**SUBJECT: Appeal of Decision of the Historic Preservation Commission
Concerning Property Located at 1176 Lullwater Road by Katharine
Butler and George Beazley**

**Application to Appeal a Decision of the DeKalb County Historic
Preservation Commission**

Applicant seeks reversal of the HPC decision on September 18, 2023, which granted a modified approval for a Certificate of Appropriateness (“COA”) for a new construction at 1176 Lullwater Road. The HPC abused its discretion in granting the COA for the following reasons:

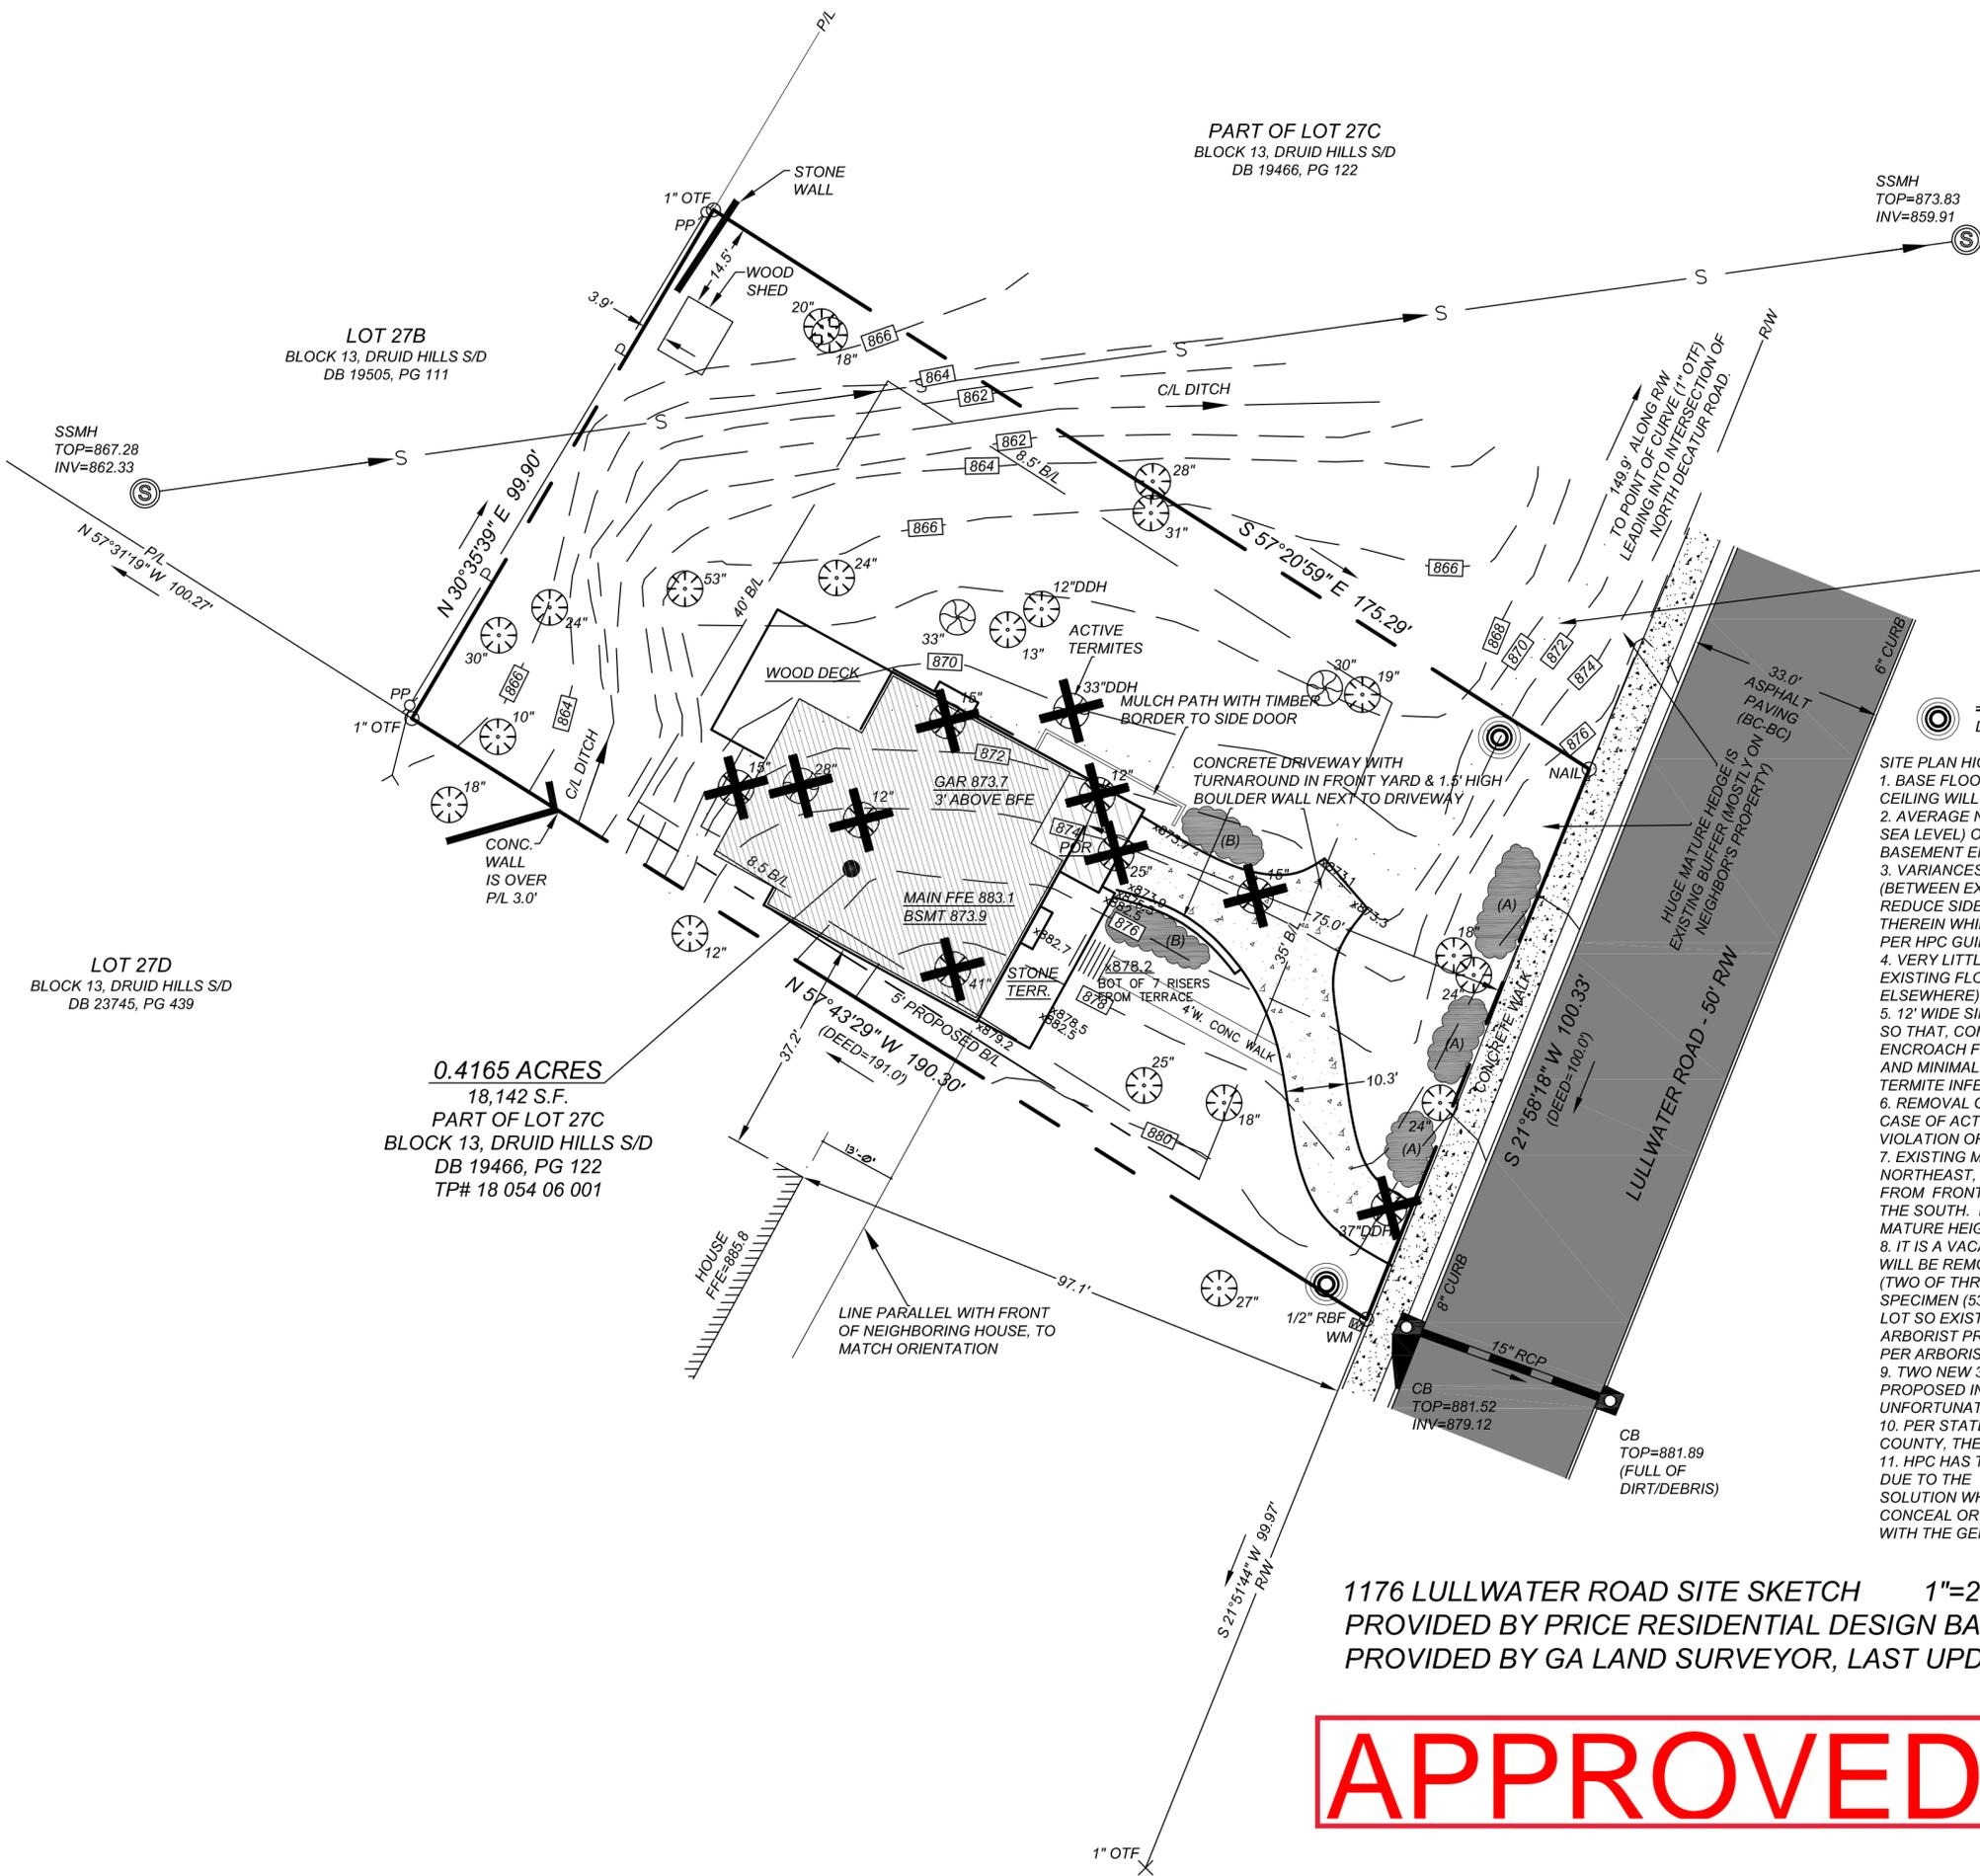
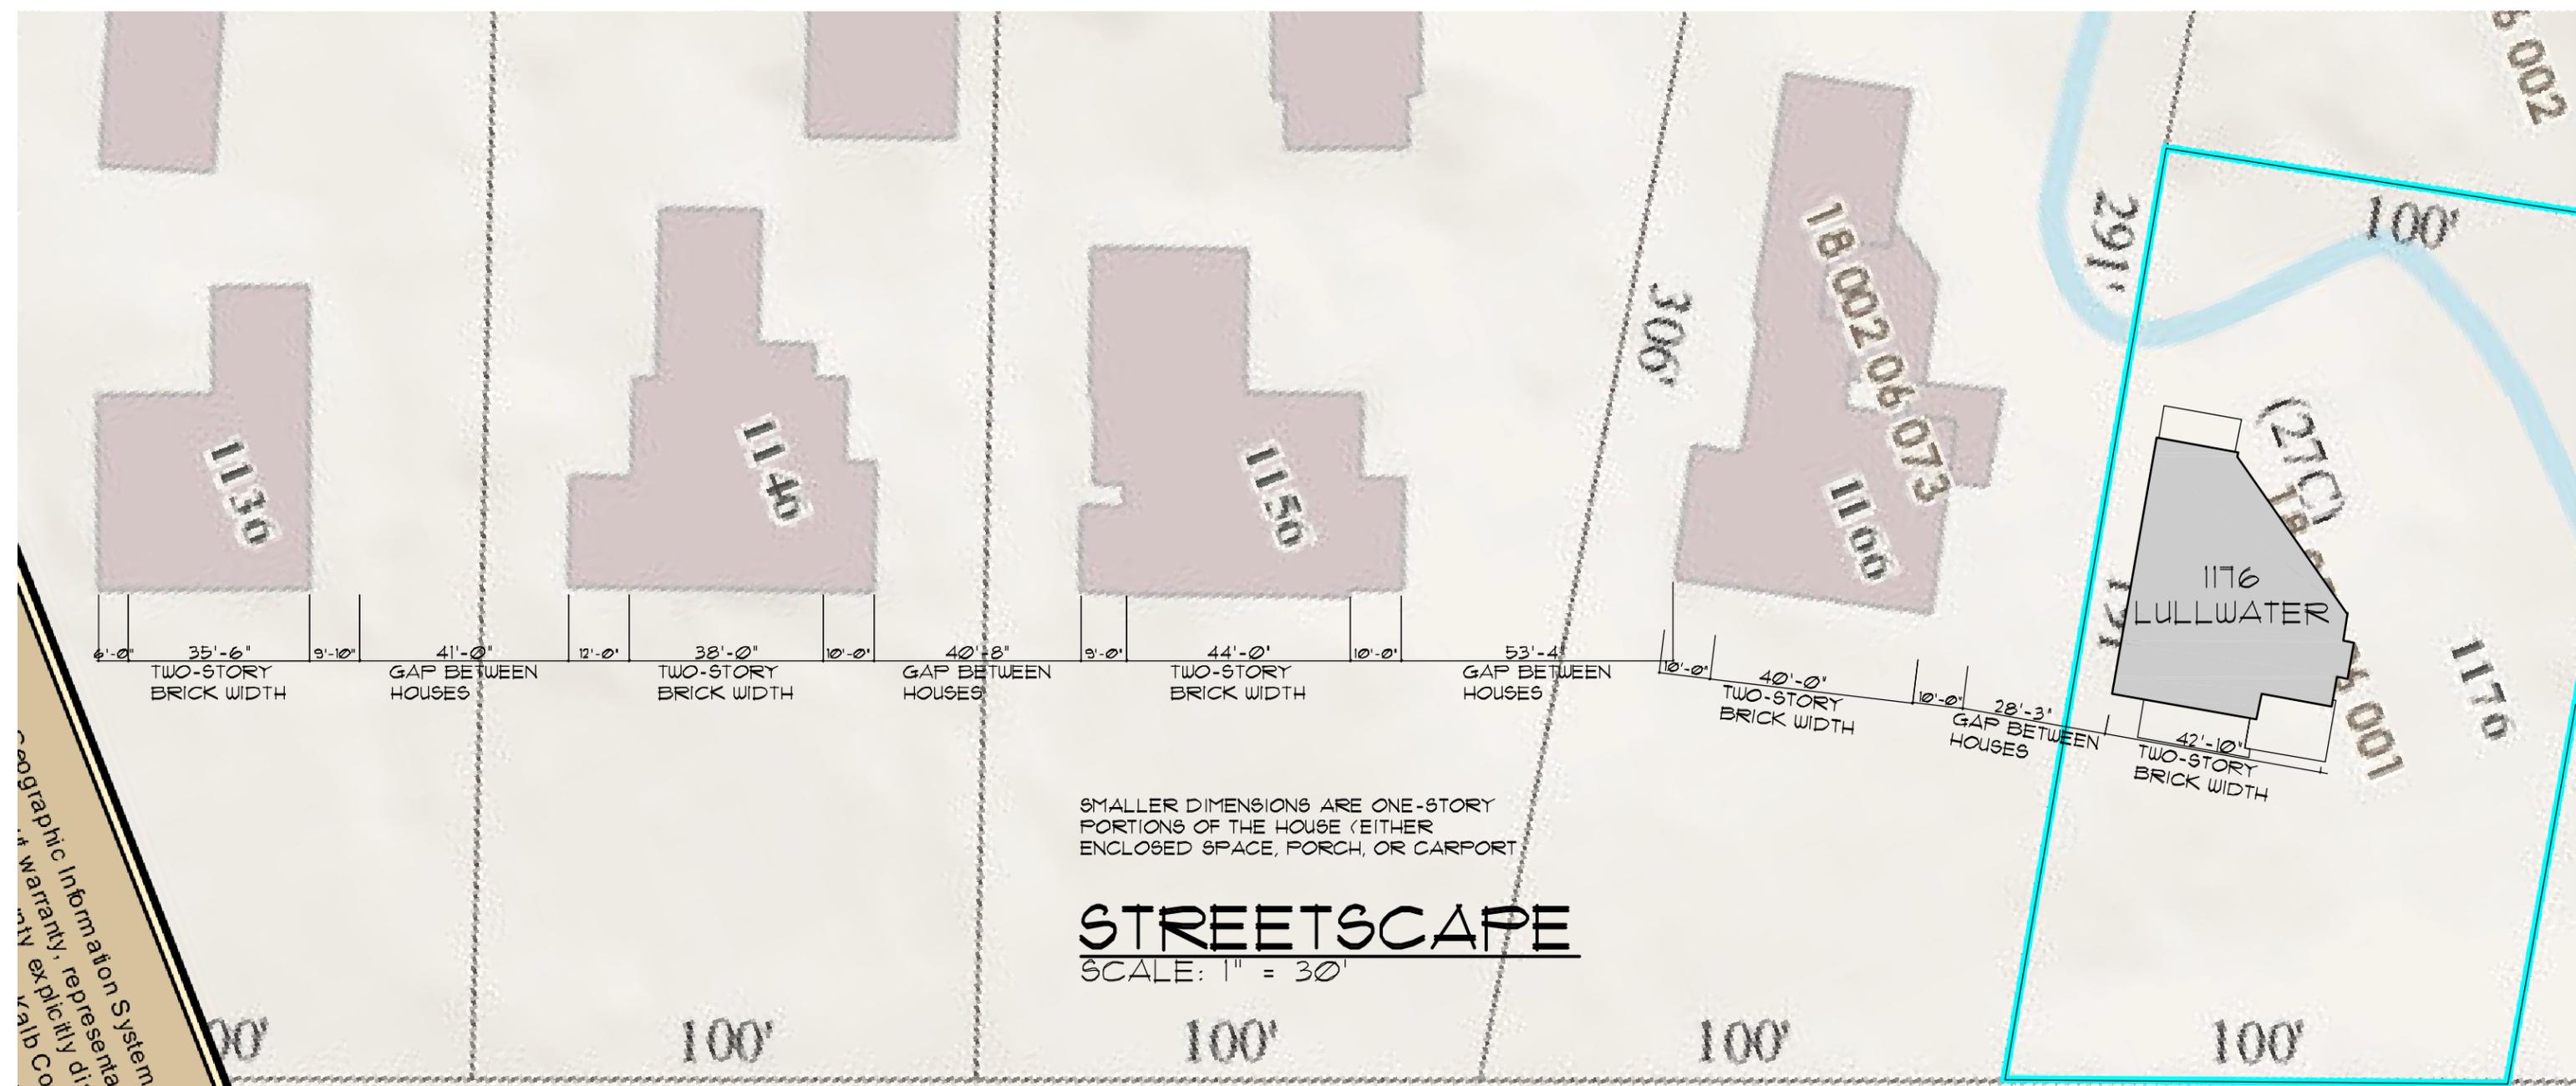
Abuse of Discretion by Issuing a COA on an Incomplete Application Without a Valid Site Plan. It was an abuse of discretion for the Historic Preservation Commission (the "HPC") to conduct the HPC meeting on September 18, 2023, and to issue a decision when the site plan submitted with the Application was no longer viable. On September 13, 2023, the Applicant's request for a stream buffer variance was denied by the Zoning Board of Appeals. The site plan included as part of the Application assumed that the variance would be granted, and the proposed structure as shown on the Application encroached into the stream buffer protected area. Since no valid site plan was before the HPC at the September 18th hearing the Application was incomplete, and it was an abuse of discretion for the HPC to render any decision at all other than to defer the hearing to a future date at such time as a revised site plan had been submitted.

- 1) Applicant applied for an administrative variance for the stream buffer. However, ZBOA Board Member Dan Wright pointed out at the ZBOA hearing on September 13, 2023 that the County denied the request earlier this week, and he stated the current site plan isn’t viable.

As stated, the County just this week denied Applicant's application for a stream buffer variance. (To date, I have been unable to obtain a copy.) The site plan before the HPC is based on the assumption that a stream buffer variance would be granted. Until this matter is resolved, it would not be prudent for the HPC to make a ruling.

FRONT ELEVATION
 NOT TO SCALE

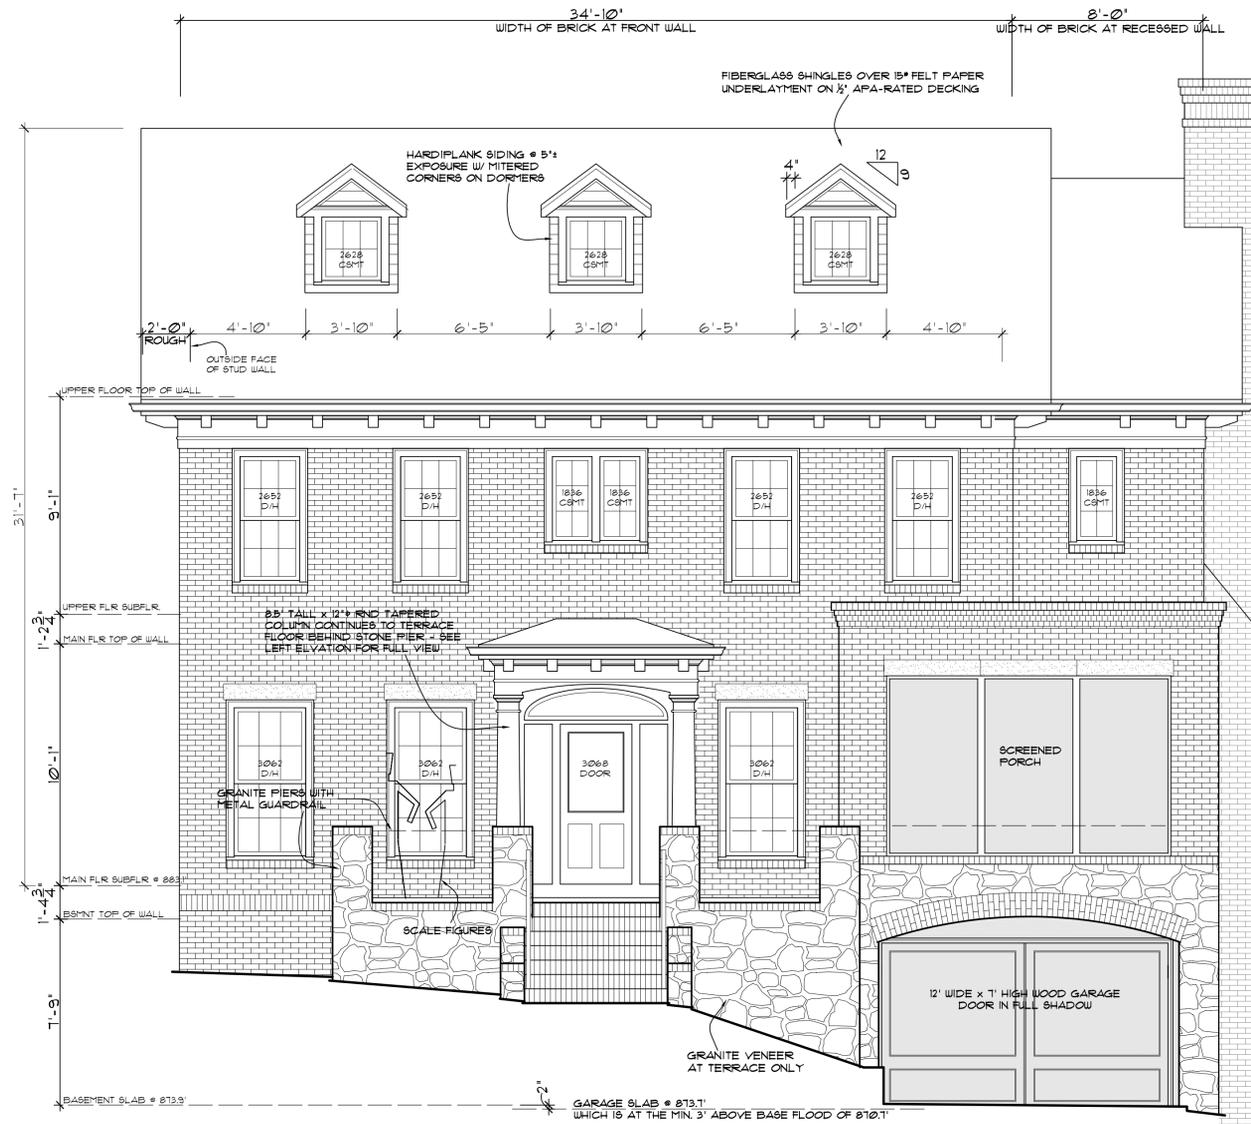
Build a house as shown in the architectural drawings with the modifications that the granite shown on the front and left side of the house will be replaced with brick and the small window on the right side of the front elevation will be replaced by a larger window matching the others on the façade.

Build a house as shown in the architectural drawings with the modifications that the granite shown on the front and left side of the house will be replaced with brick.
